# OCP NIC 3.0 Design Specification

Version 0.01

Author: OCP Server Workgroup, OCP NIC subgroup

Figure 4: Example Small Card Form Factor

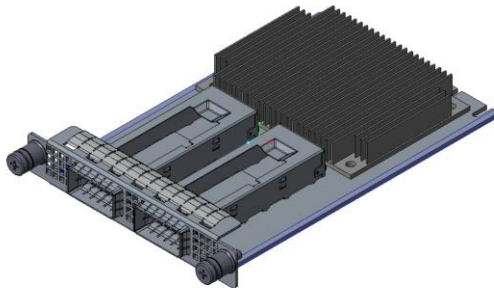
**Commented [TN2]:** Are we going to uprev the SFF-TA spec to include these 28 pins?

Figure 6: Primary Connector (4C + OCP Bay) with 4C and 2C Add-in Cards

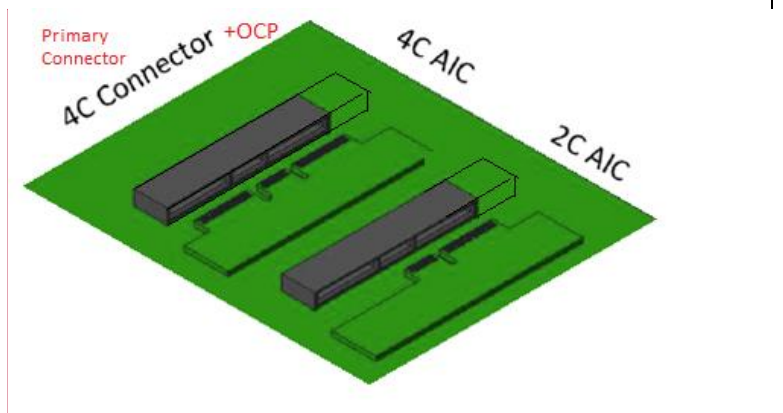
**Commented [TN3]:** This needs to be updated to show the OCP bay along with the secondary connector location..

Figure 29: Baseboard Power Sequencing

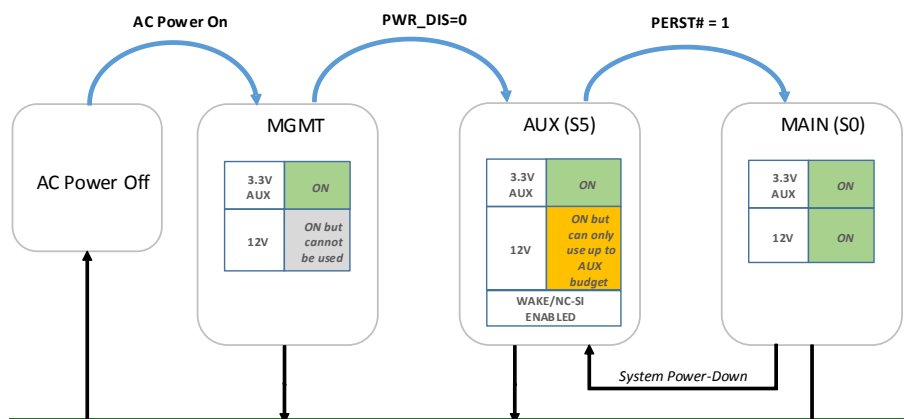
Commented [TN20]: 25W (?) – align with PCIe CEM. Table 4-1.

Figure 2830: Baseboard Power Sequencing

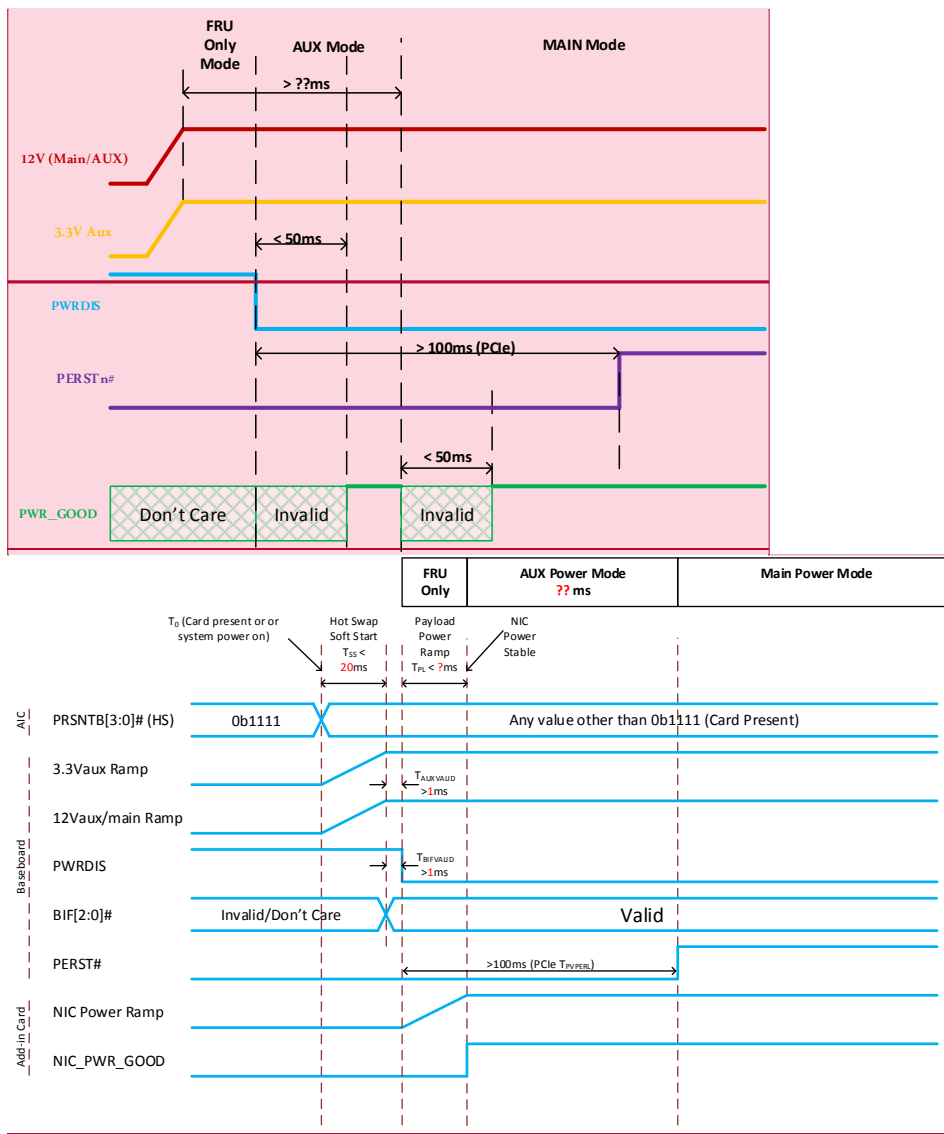
**Commented [TN22]:** What is the 12V/3.3V timing for within tolerance to PWRDIS deassertion?
